Crane Division, Naval Surface Warfare Center (NAVSURFWARCENDIV Crane) submits for review and approval, per your comments, a copy of Appendix E4 - Revised Soil Excavation Plan for Rockeye (RKI) of the Final Full Scale Operational Plan for the Bioremediation Project as enclosure (1). Enclosure (2) is the required certification statement.

RESPONSES TO USEPA COMMENTS
ON THE
DRAFT APPENDIX E-4: SOIL EXCAVATION PLAN FOR SWMU 10/15
ROCKEYE
FULL-SCALE OPERATIONAL PLAN FOR SOILS BIOREMEDIATION FACILITY

**APPENDIX E4
SWMU-10/15, ROCKEYE SOIL EXCAVATION PLAN
FOR FULL-SCALE OPERATIONS**

Figure E4-1

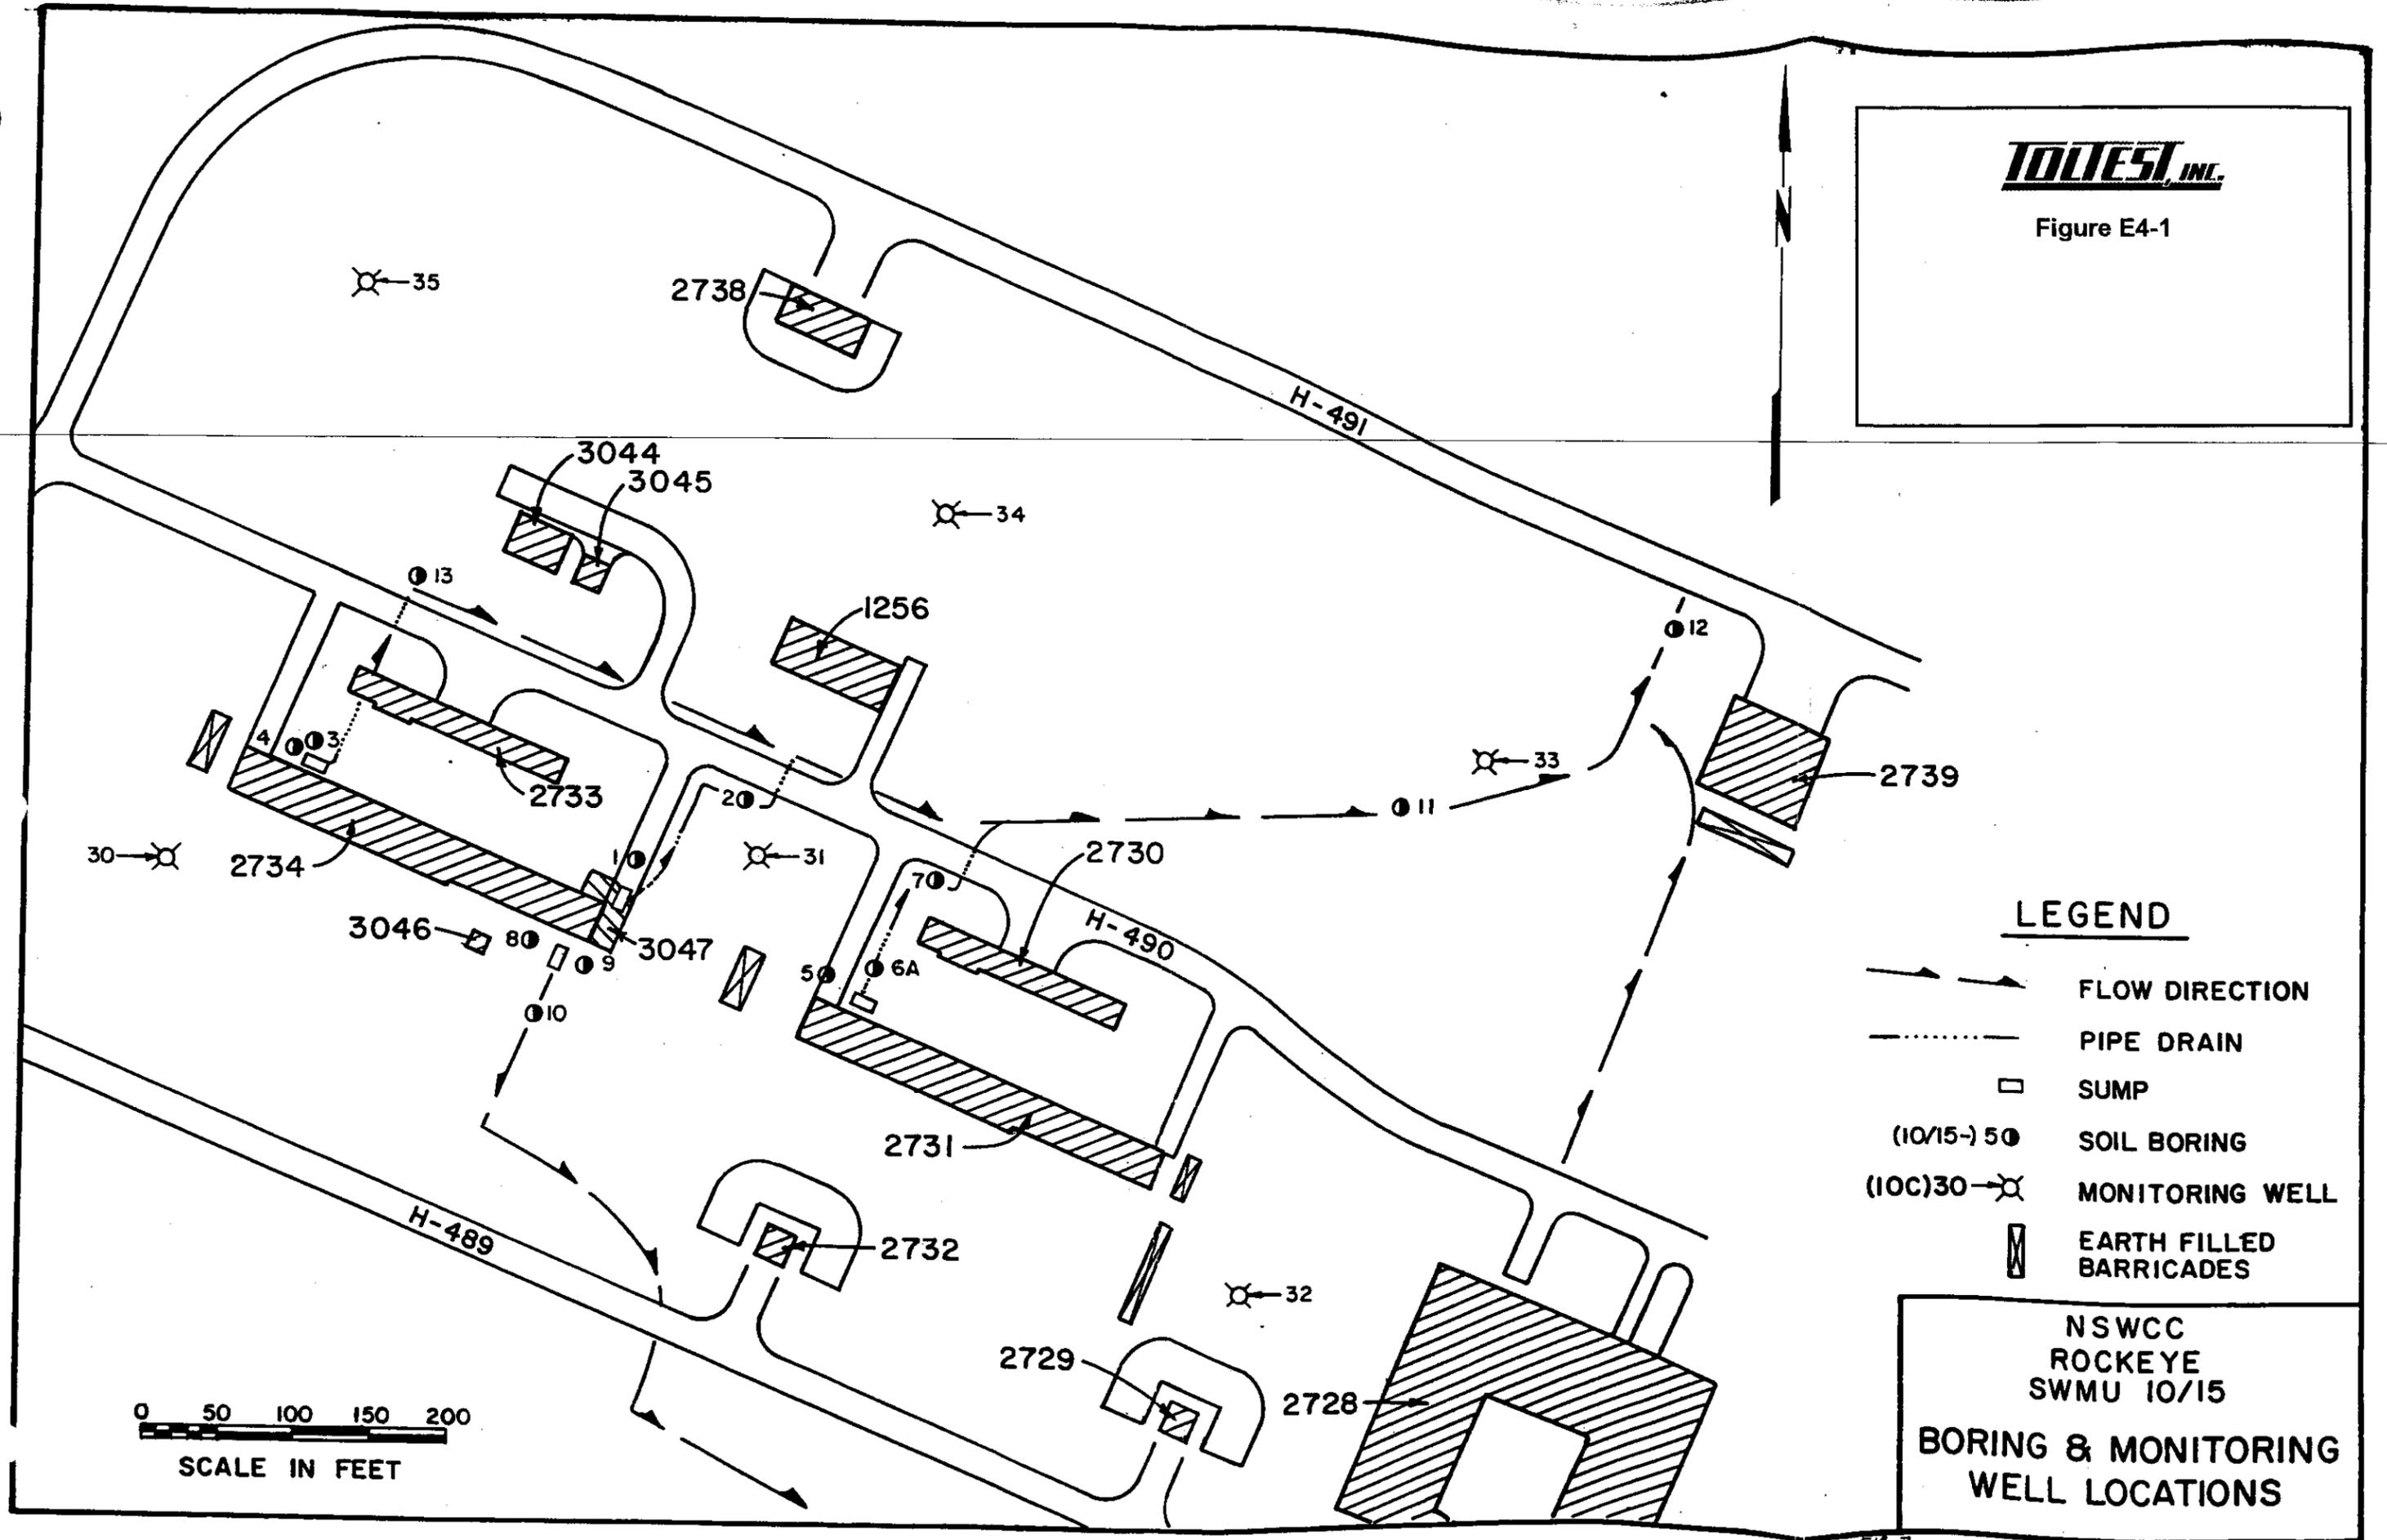
COMMENT 6: Section 1.2, pg E4-6: it is stated that Figure E4-1 shows drainage ditches. I do not have Figure E4-1. Figure E4-3 shows only buildings, sumps, and roads.

RESPONSE 6: Figure E4-1, taken from ACOE 1998, is included with the plan. Several drainage ditches leading from the sumps are depicted on this figure.

Figure E4-2
Transportation Route from ROCKEYE to the BIOFACILITY

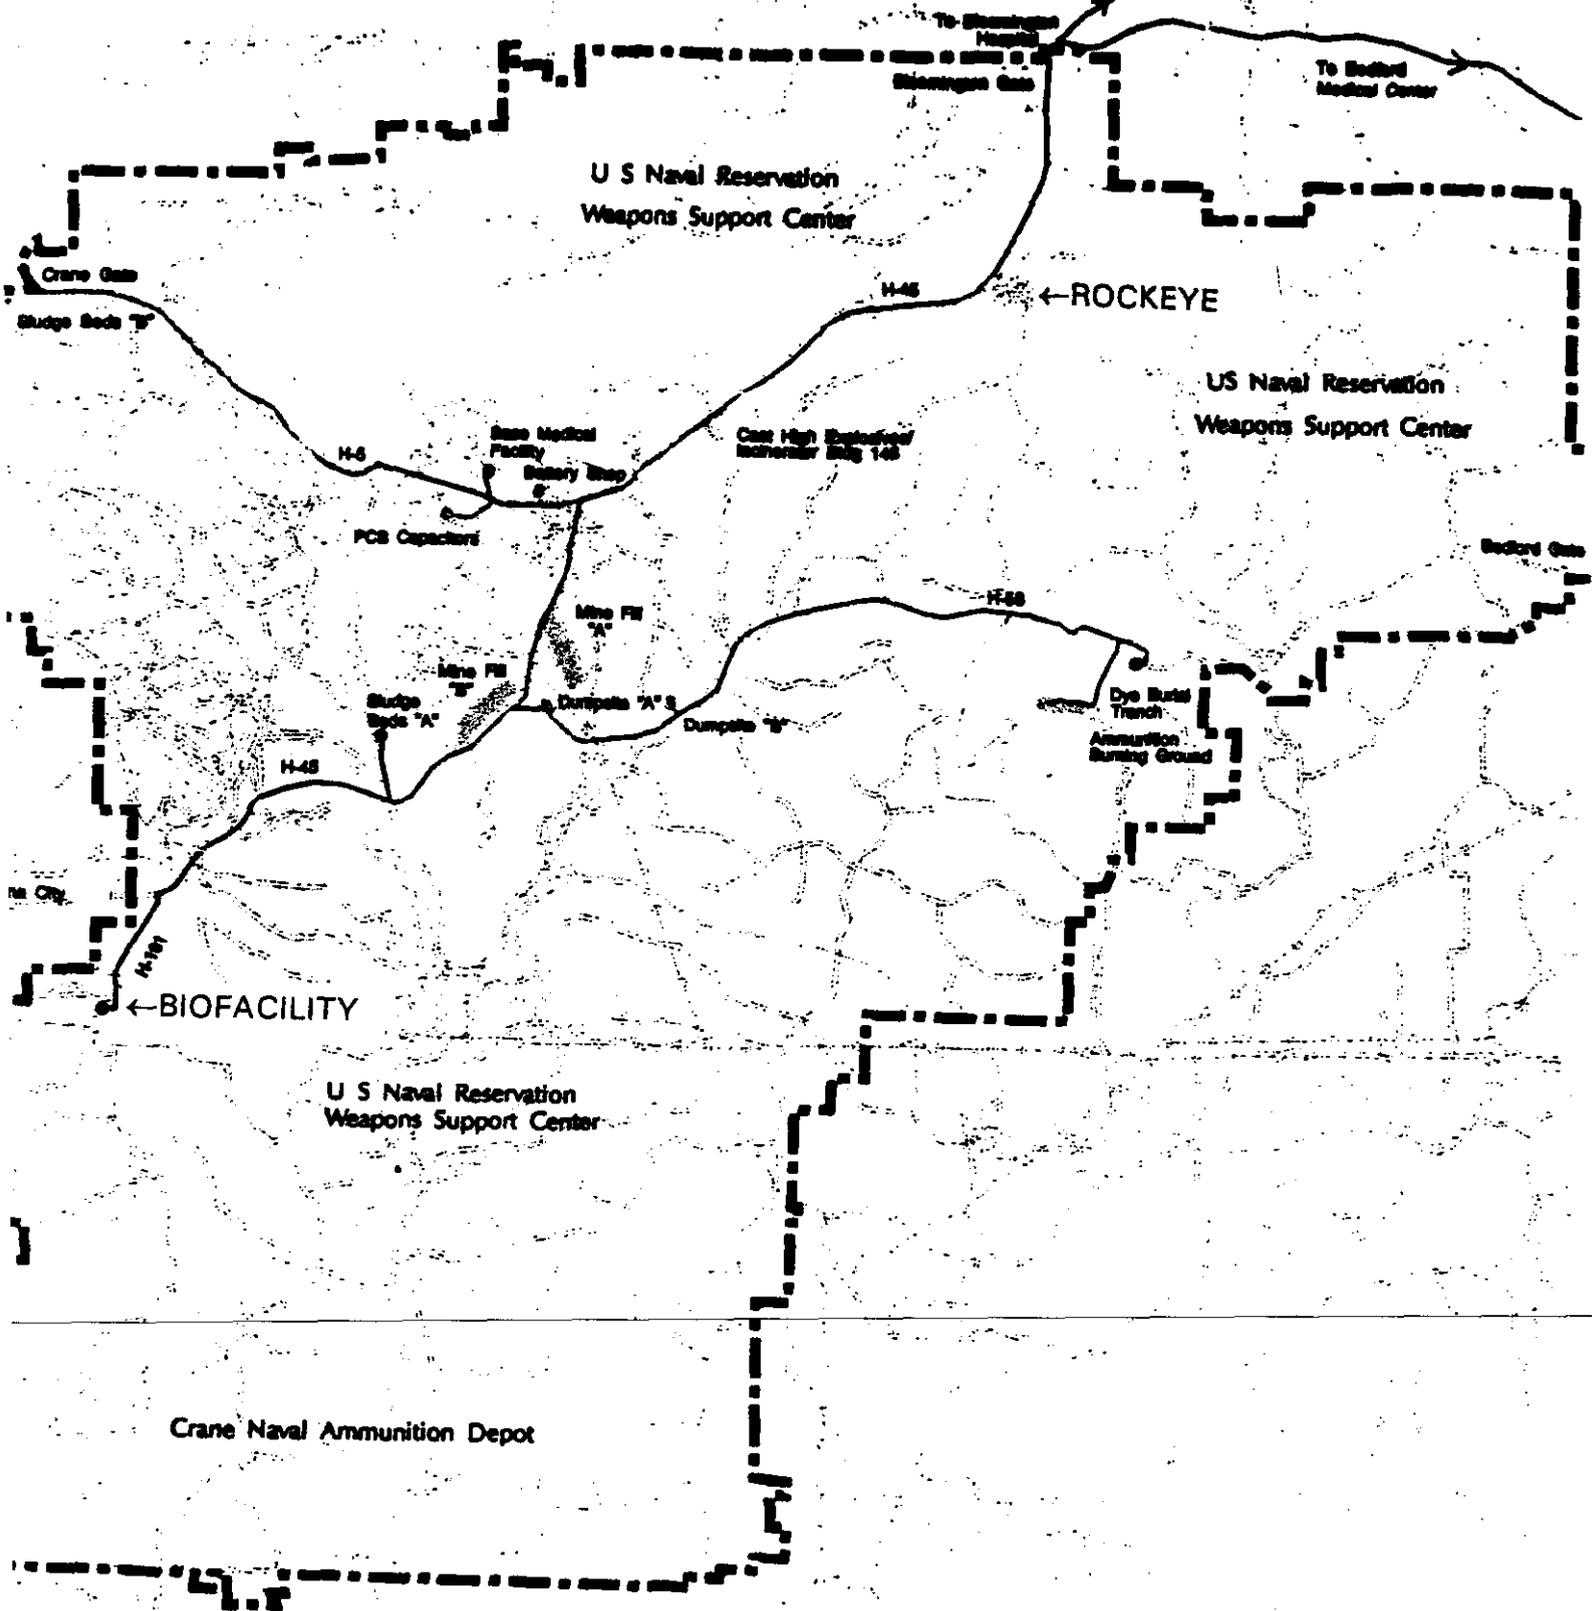
COMMENT 8: Section 4.5, pg. E4-13: Please provide Figure E4-2 – Transportation route from Rockeye to Bioremediation Facility.

RESPONSE 8: This figure is included in the plan.

**FIGURE E4-3
SITE PLAN
NSWC
CRANE, INDIANA**

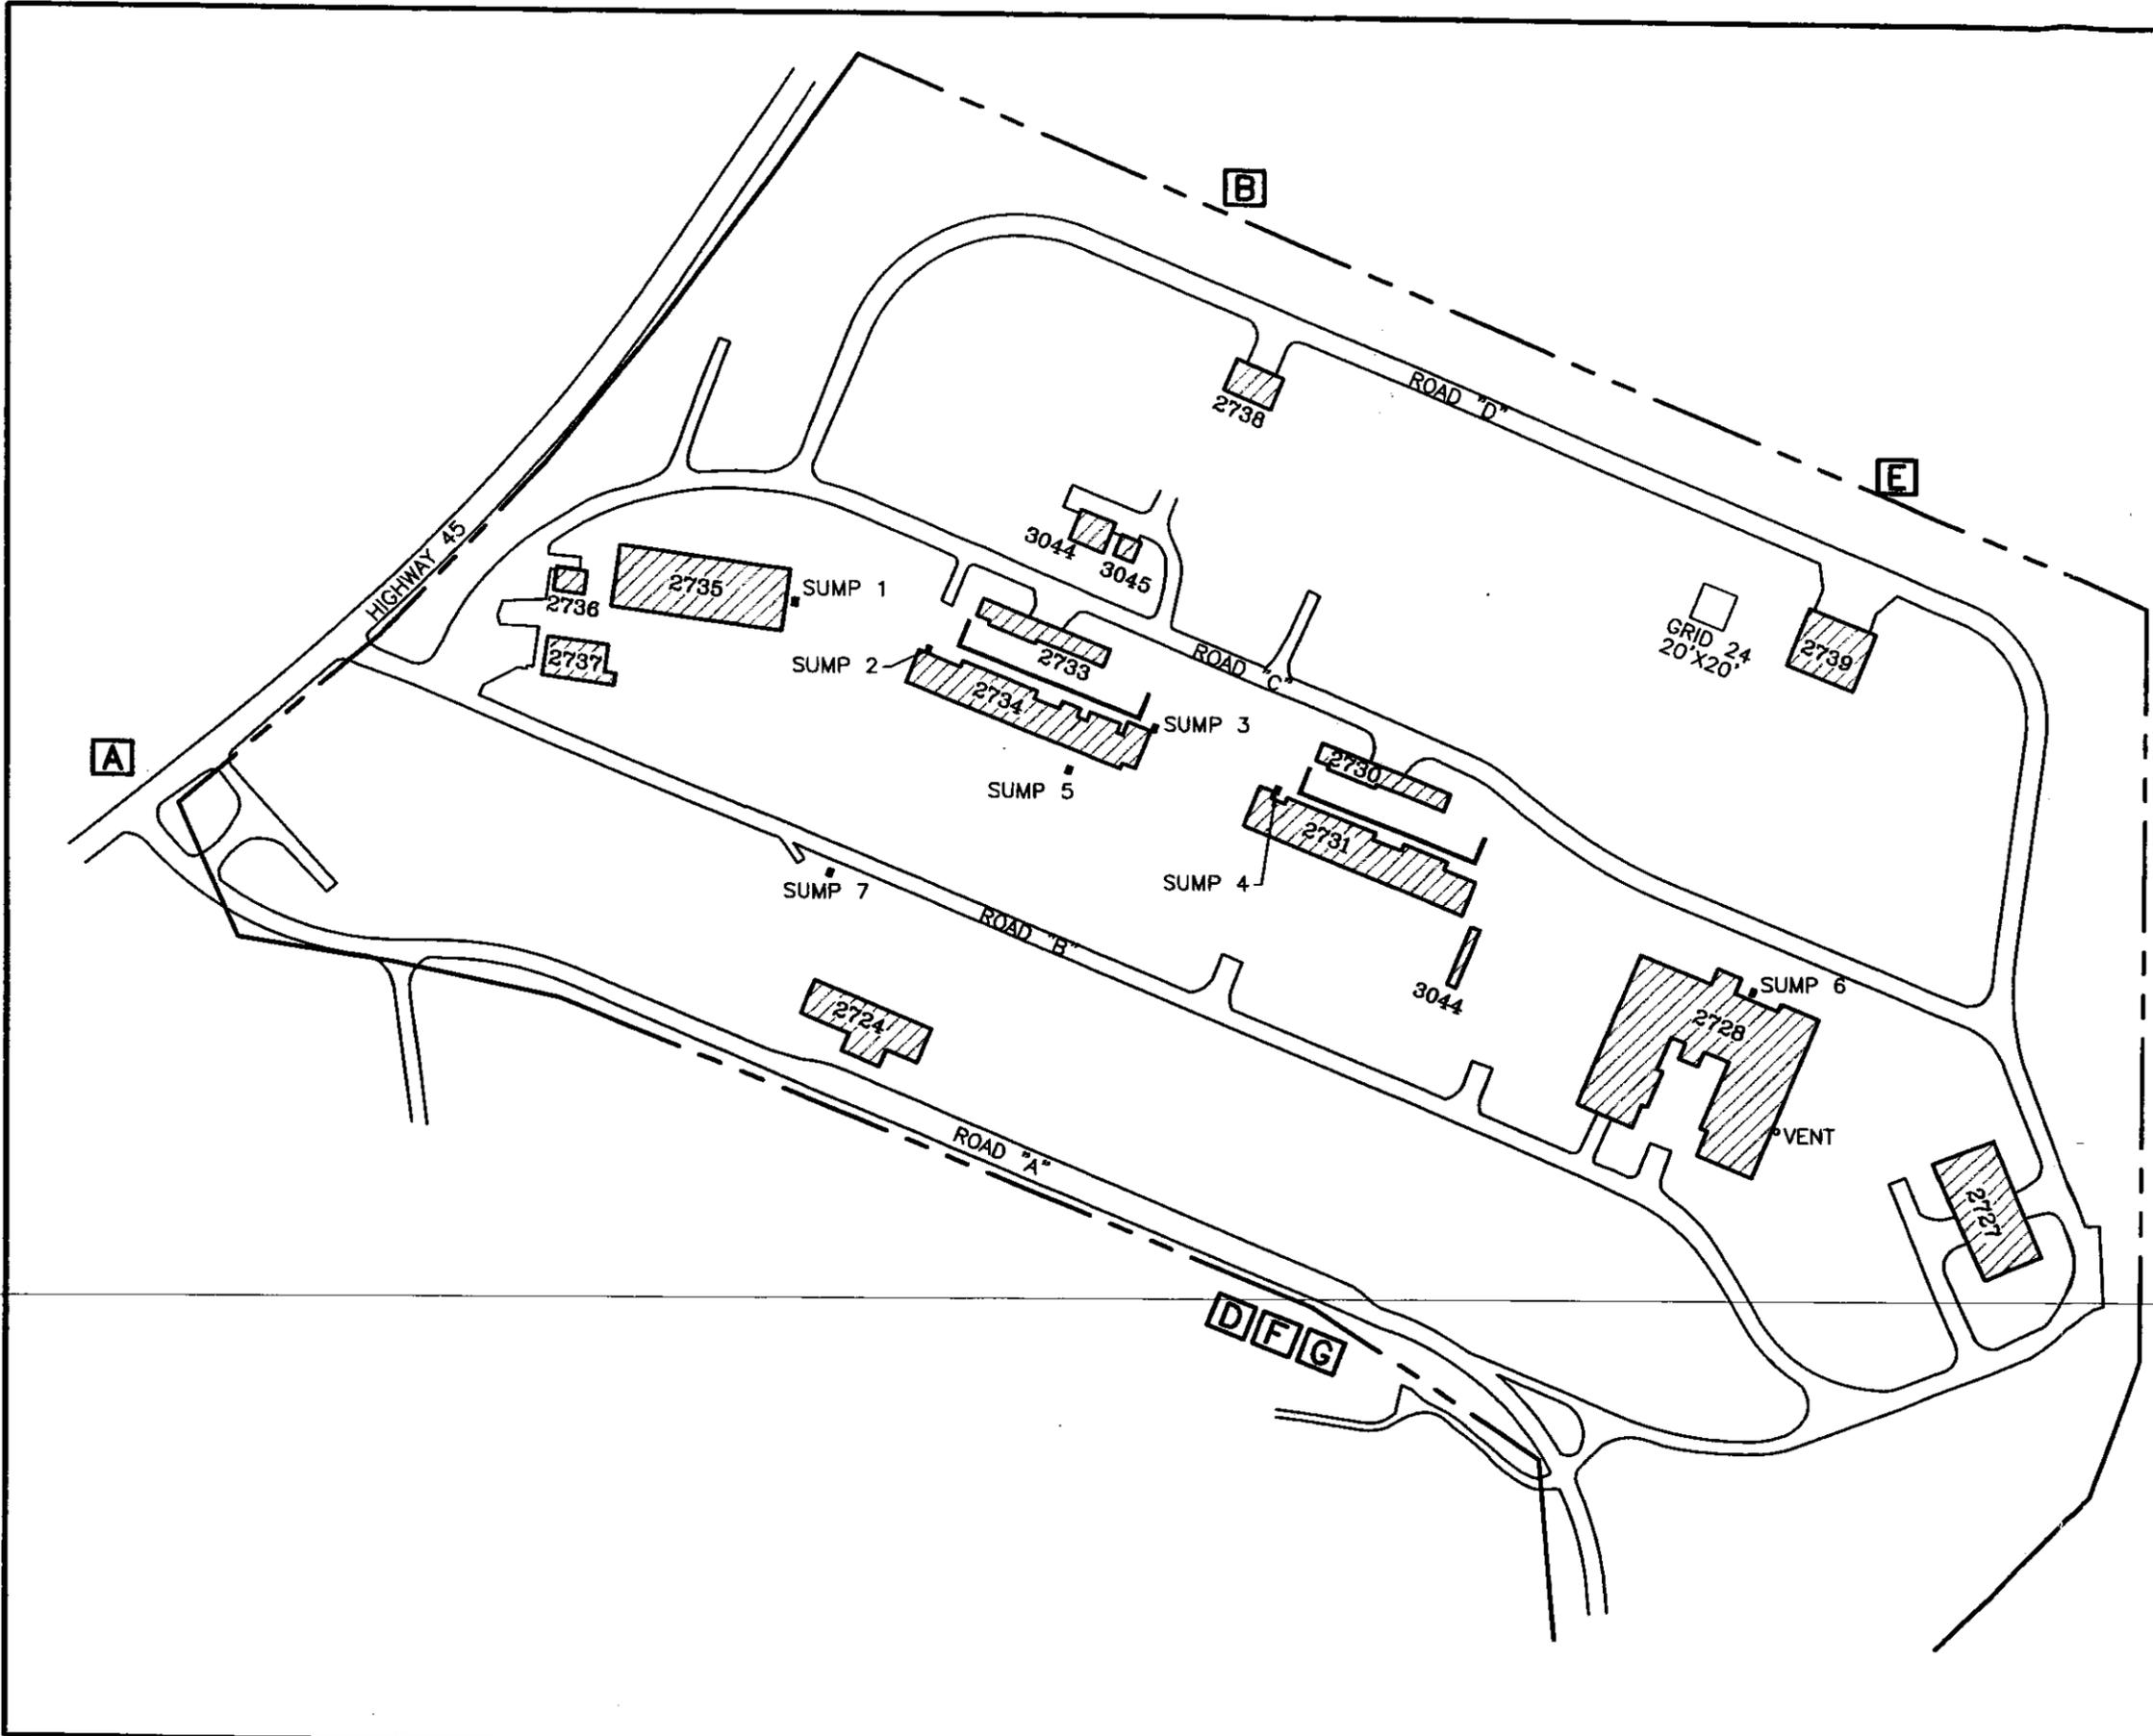
COMMENT 5: In the title for Section 5.4, the word "sampling" is missing. Also, I assume that the figures will show the grid layouts?

COMMENT 7: Section 1.2, Section 4.2, & Attachment E4-4 refer to a General Plot Plan for Rockeye (Drawing No. 538126). I do not have this drawing. I received Figure E4-3 (Drawing No 37324-01) and Figure E4-4 (Drawing No. 37324-02) from Crane with cover letter dated October 21, 1999. Please supply the General Plot Plan drawing. Also make the name references to this drawing consistent between sections.

RESPONSE 5: The word "sampling" has been added to the title of Section 5.4. Figures E4-3 and E4-4 show initial grid layouts.
